**PILOT-SCALE TREATABILITY STUDY WORK PLAN FOR  
THE CHROMIUM AND VOC GROUNDWATER OPERABLE UNIT (OU) 2  
EE/CA  
STRATFORD ARMY ENGINE PLANT  
Stratford, Connecticut**

**November 3, 1999**

**RESPONSE TO USEPA COMMENTS ON DRAFT PILOT TEST WORK PLAN**

### DRAFT PILOT-SCALE TREATABILITY STUDY WORK PLAN, CHROMIUM AND VOC GROUNDWATER OPERABLE UNIT (OU) 2, EE/CA STRATFORD ARMY ENGINE PLANT SEPTEMBER 27, 1999

<b>Harding Lawson Associates</b> Engineering and Environmental Services	<b>SITE LOCATION MAP</b>	
	OU2 TREATABILITY STUDY	
TOTAL ENVIRONMENTAL RESTORATION CONTRACT STRATFORD ARMY ENGINE PLANT	47254	<b>FIGURE 1</b>

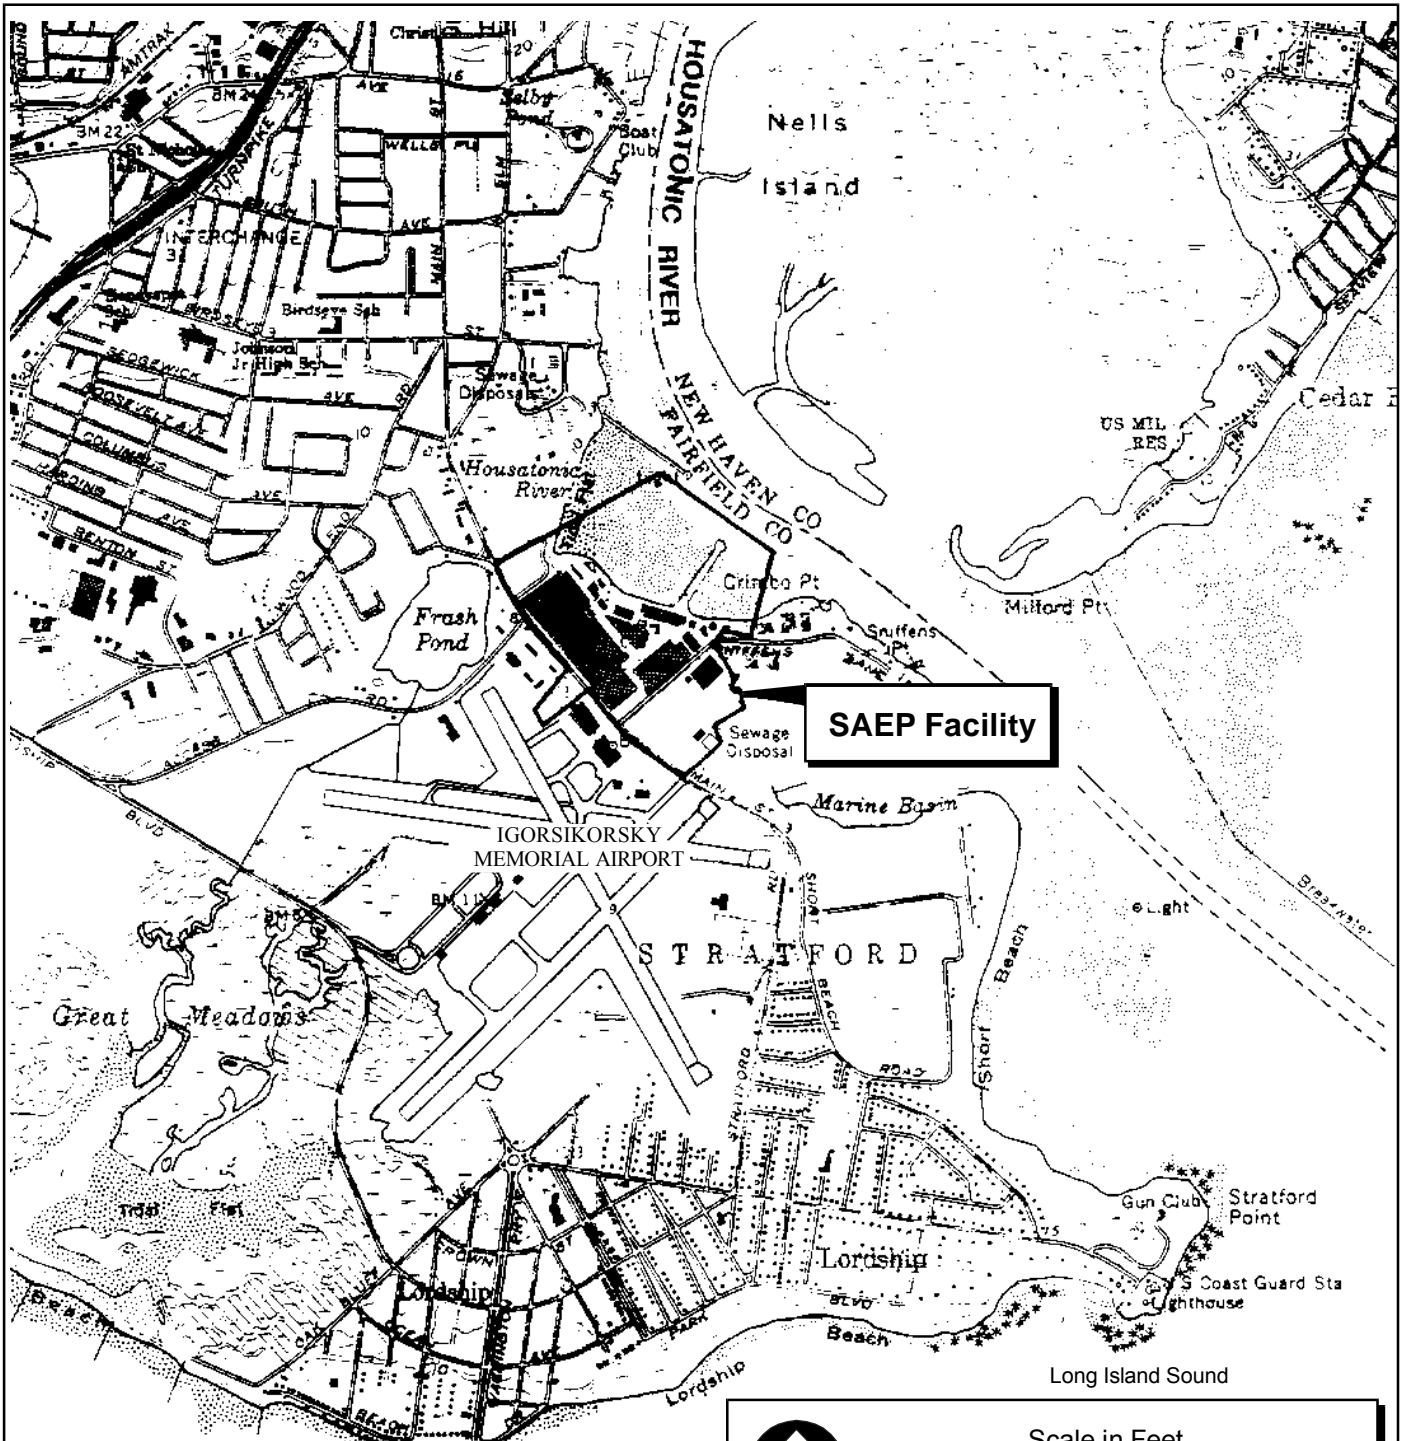
24. **Comment: Figure 1.** This figure references the Installation Restoration Program at the Massachusetts Military Reservation in the title block. Please correct the reference.

**Response:** The Reference has been corrected.

**FIGURE 2**  
**SITE FEATURES**  
**OU2 PILOT-SCALE TREATABILITY STUDY**  
**STRATFORD ARMY ENGINE PLANT**  
 Harding Lawson Associates

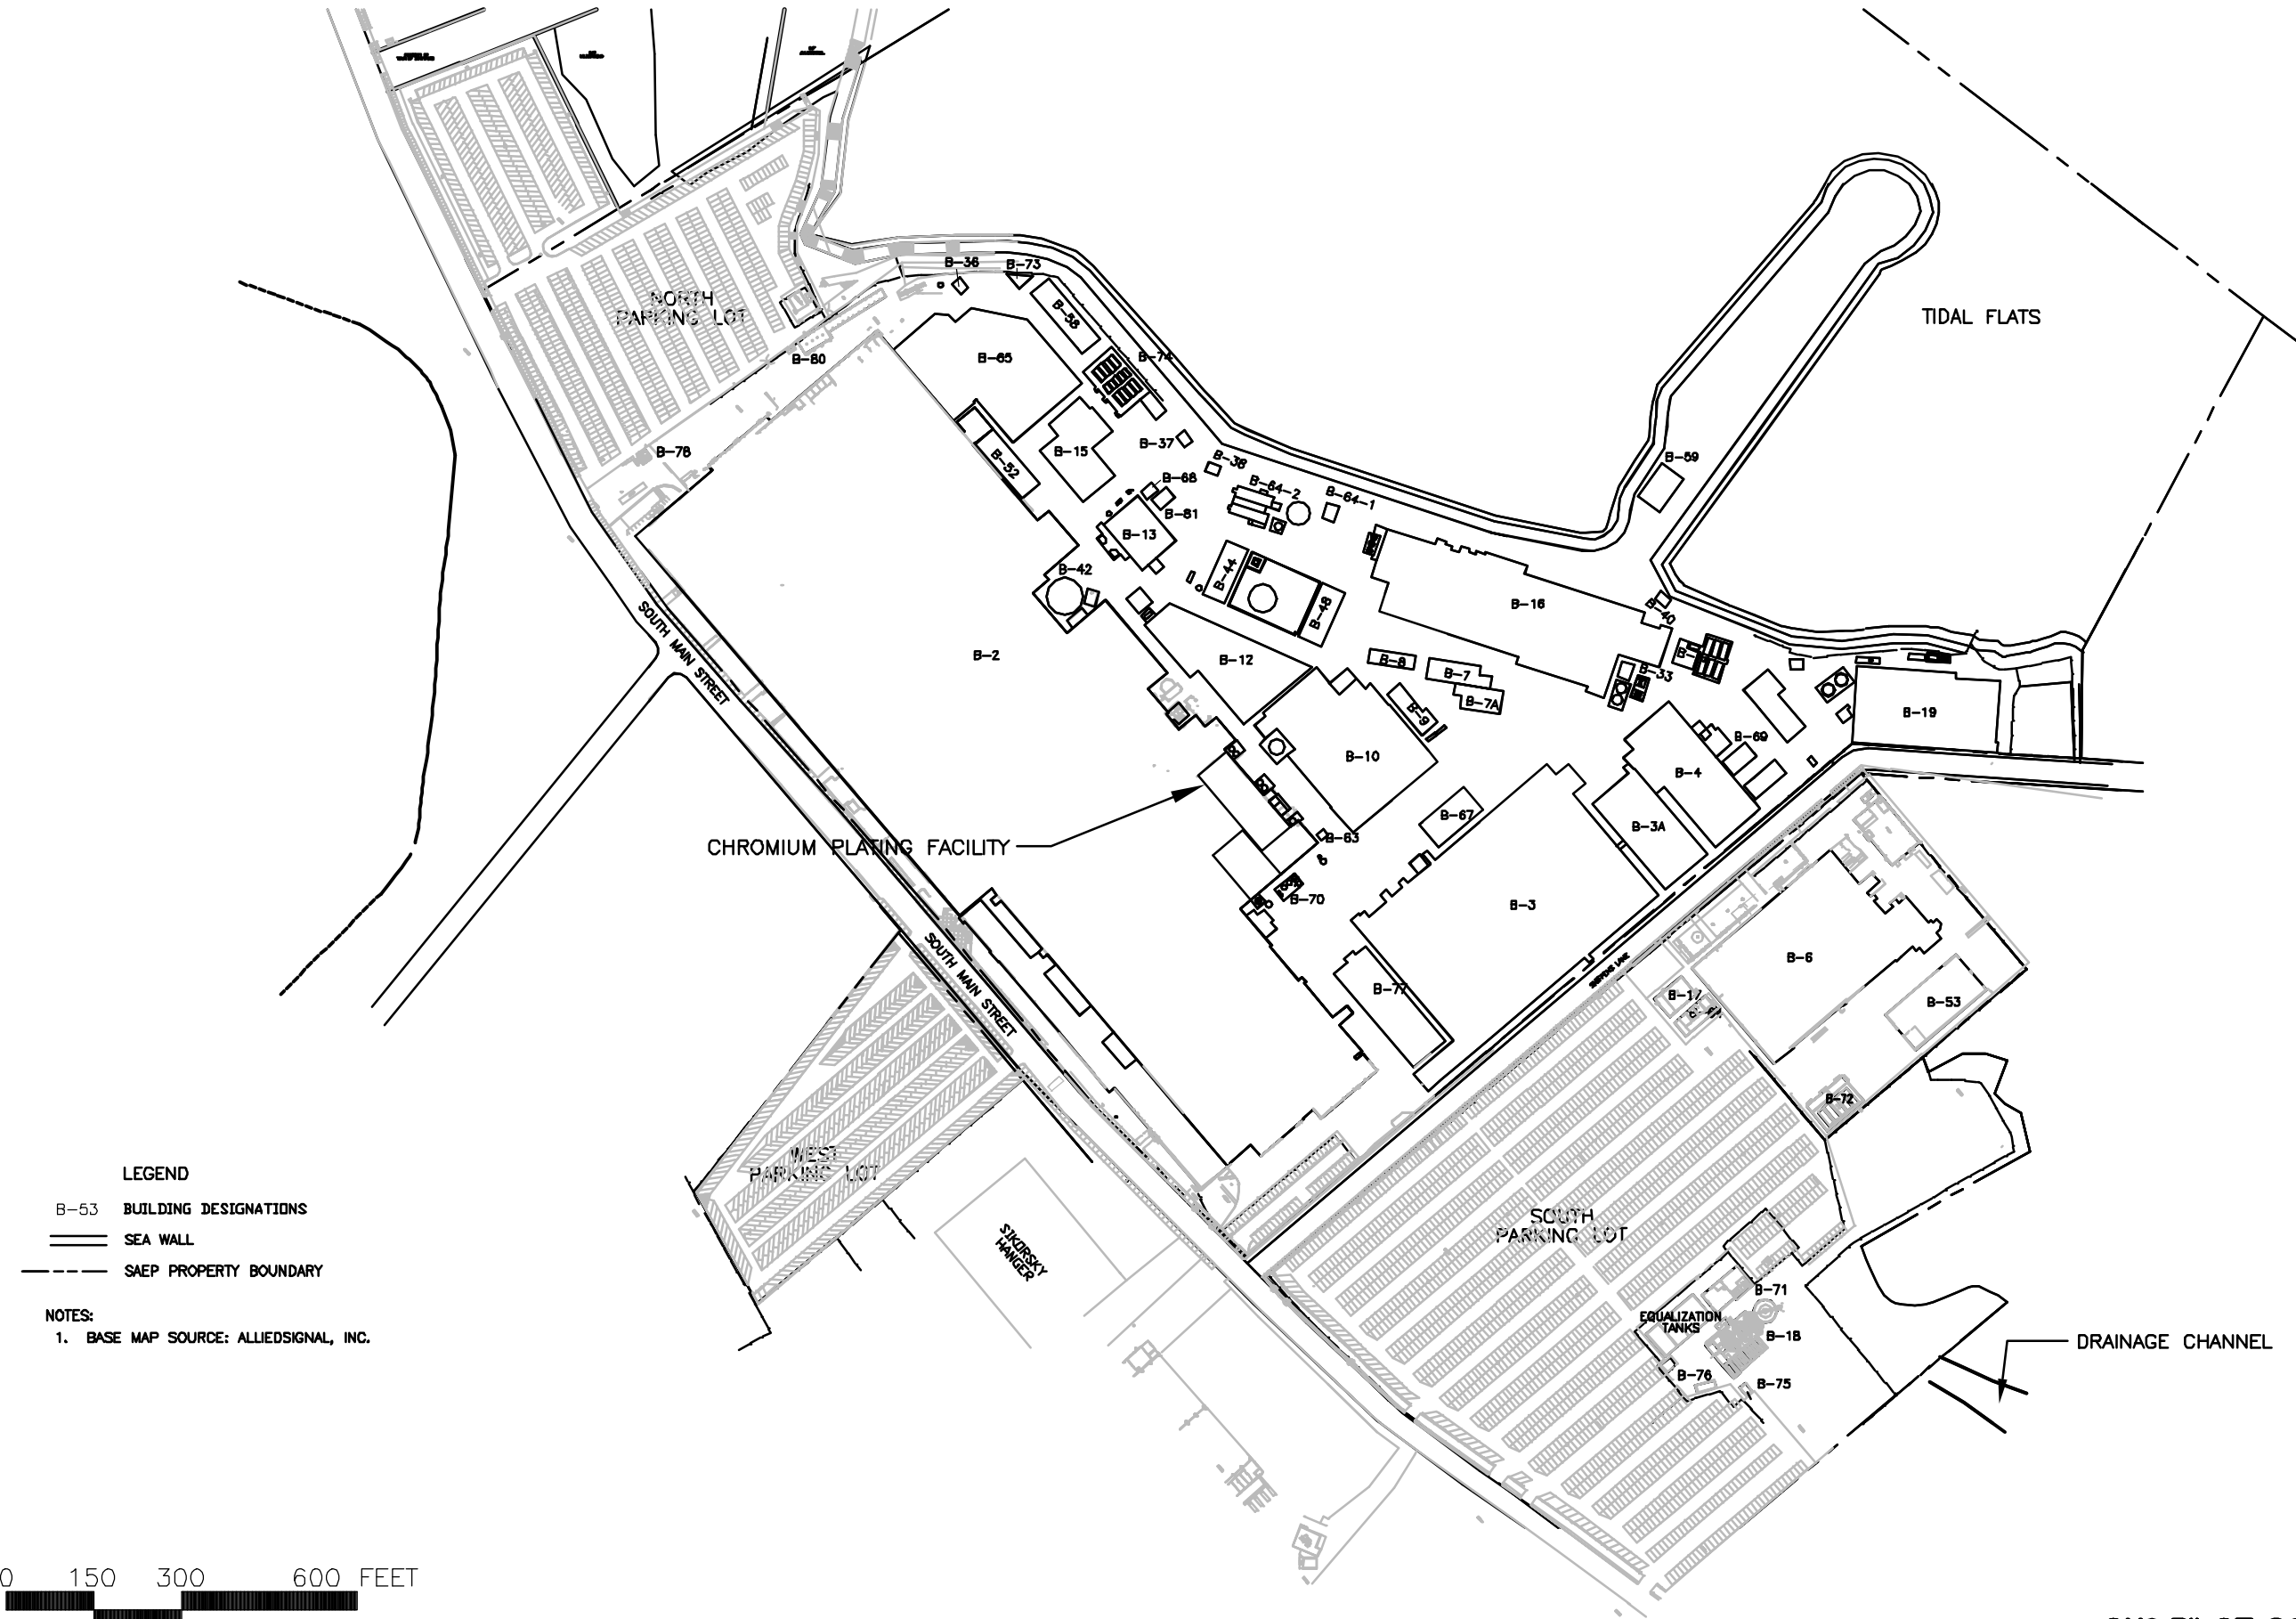
25. **Comment: Figure 2.** Notes 1 and 3 are not pertinent to this figure. Please delete them.

**FIGURE 12**  
**CHROMIUM PLATING FACILITY**  
**PROPOSED PILOT TEST LAYOUTS**  
**OU2 PILOT-SCALE TREATABILITY STUDY**  
**STRATFORD ARMY ENGINE PLANT**

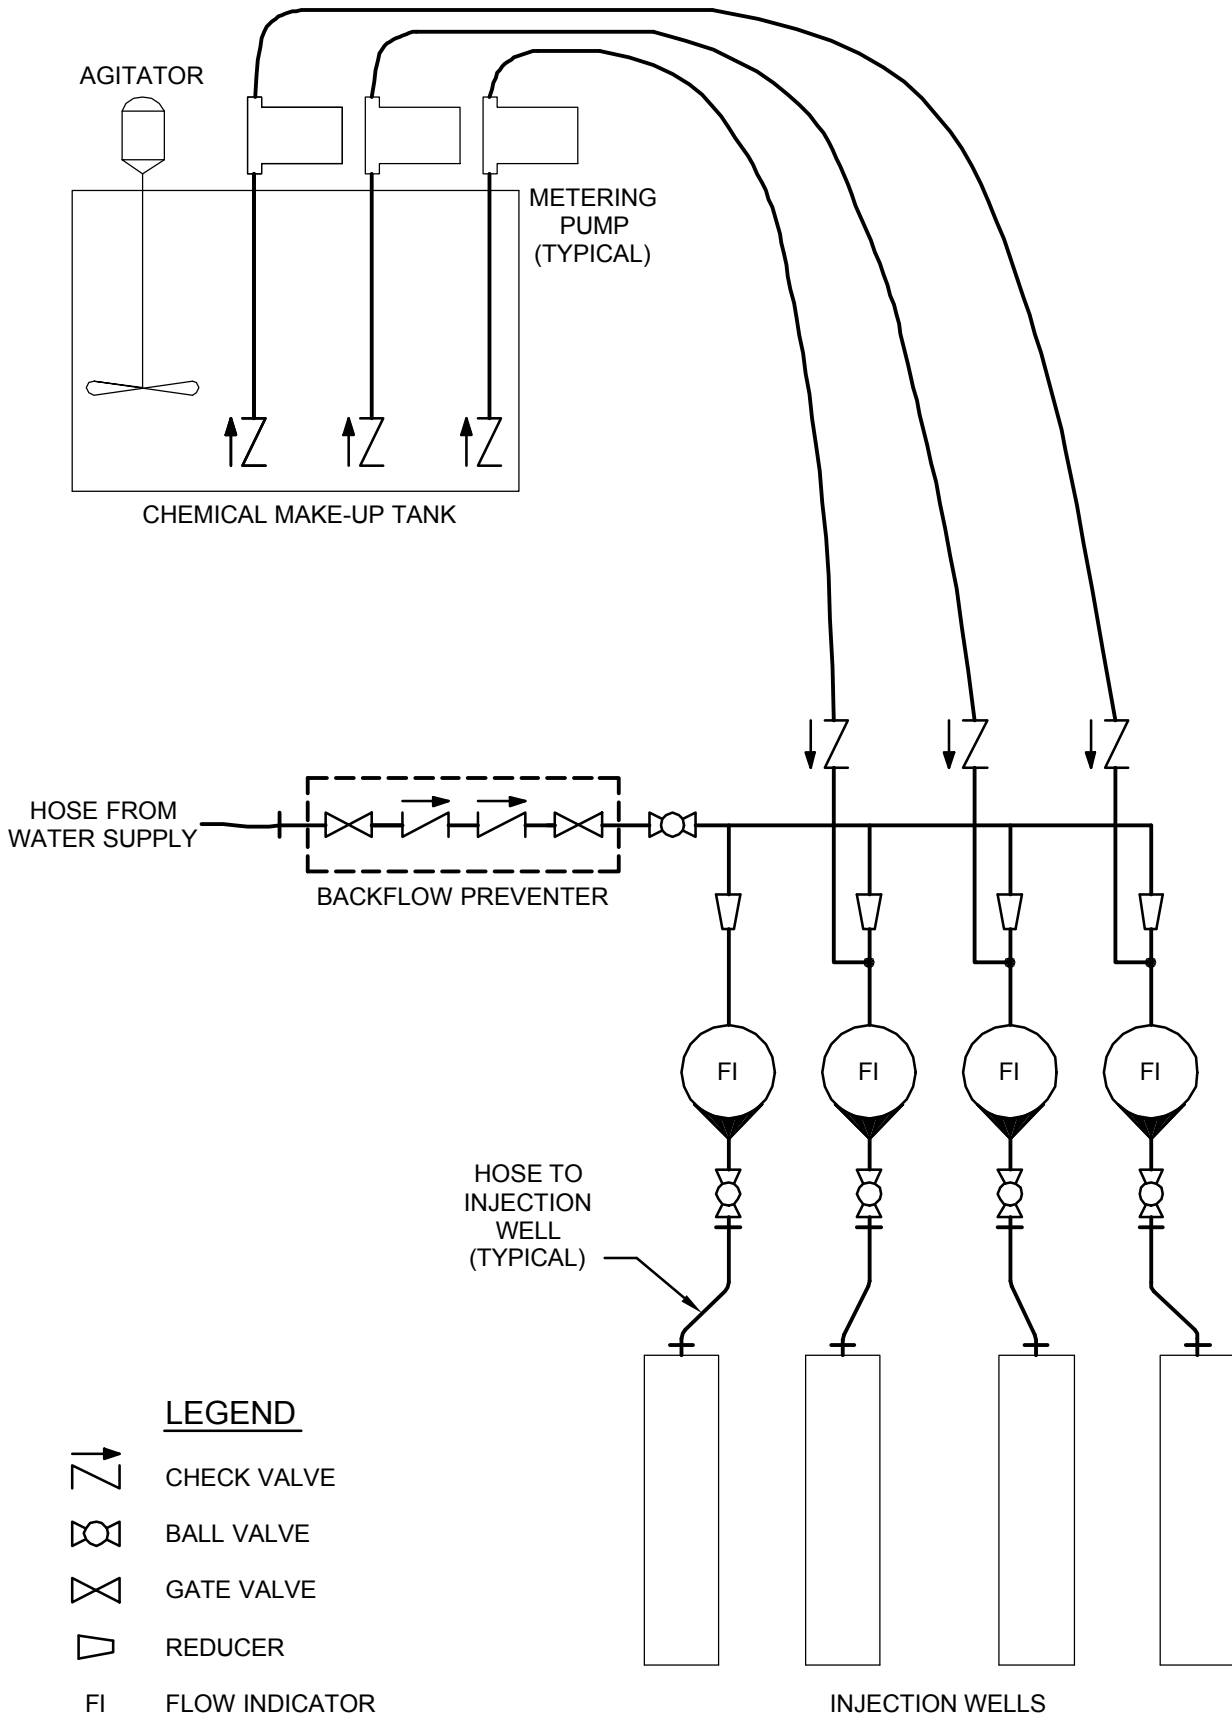
7. **Comment: Page 2-2, § 2.2.1.** The last sentence in the second to last paragraph refers to a final round of groundwater sampling conducted one week after system shutdown. However, Figure 12 and Table 4 state that two rounds of sampling will occur one and two weeks after shutdown. Clarify this discrepancy.
